UNITED STATES PATENT AND TRADEMARK OFFICE

APPLICATION NO.	FILING DATE	FIRST NAMED INVENTOR	ATTORNEY DOCKET NO.	CONFIRMATION NO.
09/876,506	06/06/2001	Matthew D. Giere	10006598-1	9309

Office Action Summary

DETAILED ACTION

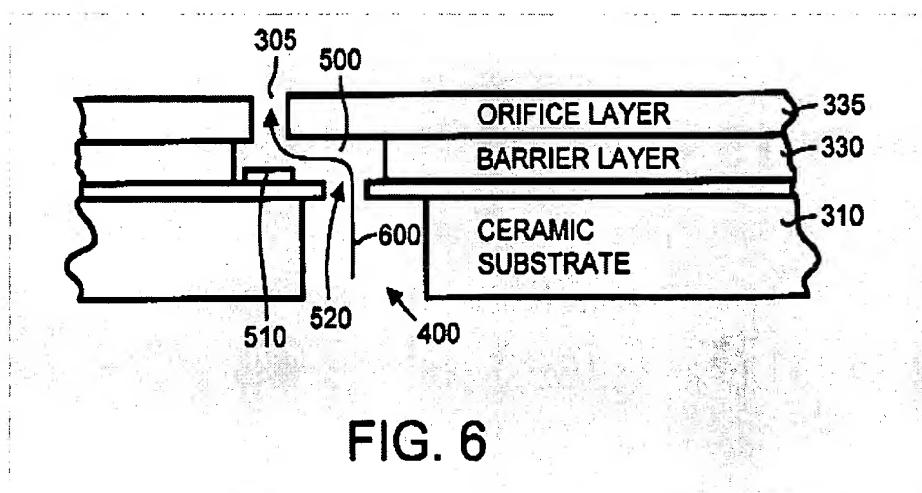
Childers et al. disclose an ink jet printhead comprising:

- a substrate (FIG. 6, element 310);
- an ink feed slot formed through the substrate (FIG. 6, element 400);
- a thin film layer (FIG. 6: the layer that is between layer 330 and layer 310)

disposed on a surface of the substrate (FIG. 6, element 310), the thin film layer defining a plurality of firing resistors (FIG. 6, element 510), a plurality of ink feed openings (FIG. 6, element 520) formed through the thin film layer to provide respective ink paths through the thin film layer from the ink feed slot (FIG. 6: the ink path 600);

a barrier/orifice structure (FIG. 6, elements 330 and 335) disposed on the thin film layer, the structure defining an array of nozzles arranged in a plurality of nozzles columns (FIG. 4A, element 420) and an array of firing chambers (FIG. 6, element 500) in correspondence with correspondence with the array of nozzles;

the firing resistors being arranged in correspondence with the firing chambers (FIG. 6, element 510 and FIG. 5, element 410);

the barrier/orifice structure further comprising a continuous rib portion extending between adjacent first and second ones of the plurality of nozzle columns to fluidically separate the first and the second ones of the nozzle columns (FIG. 5-6: the layers 330 and 335 extend in a direction that connects ink feed openings 520 of two nozzle columns);
